SUBJECT: Aurora Municipal Airport
Aurora, Illinois
Kane County
Illinois Project Number: ARR-4915
SBG Project Number: 3-17-SBGP-184/220/TBD
Contract No. AU074
Item No. 01A, September 18, 2026 Letting
Addendum A

NOTICE TO PROSPECTIVE BIDDERS

REHABILITATE
AIRFIELD LIGHTING
VAULT AND REPLACE
VAULT GENERATOR

GENERATOR DETAILS

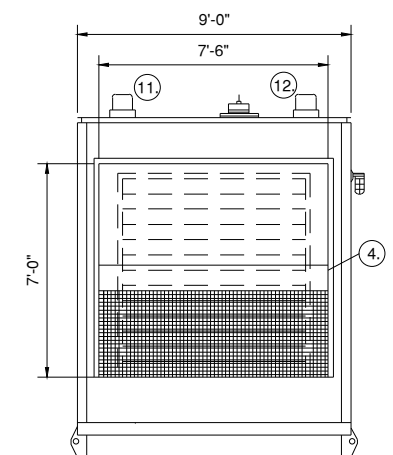
Revise Keyed Notes No. 1 on Sheet 11 of the plans to "Factory-fabricated, weatherproof, corrosion-resistant walk-in enclosure 108"W X 120"H X 252"L suitable for continuous outdoor exposure in cold climates. Enclosure shall include lockable vandal-resistant access doors, acoustical treatment, thermal insulation with perforated metal liner, and provide a minimum protection rating of NEMA 3R."

1. FACTORY-FABRICATED, WEATHERPROOF, CORROSION-RESISTANT WALK-IN ENCLOSURE 108"W x 120"H x 252"L SUITABLE FOR CONTINUOUS OUTDOOR EXPOSURE IN COLD CLIMATES. ENCLOSURE SHALL INCLUDE LOCKABLE VANDAL-RESISTANT ACCESS DOORS, ACOUSTICAL TREATMENT, THERMAL INSULATION WITH PERFORATED METAL LINER, AND PROVIDE A MINIMUM PROTECTION RATING OF NEMA 3R.
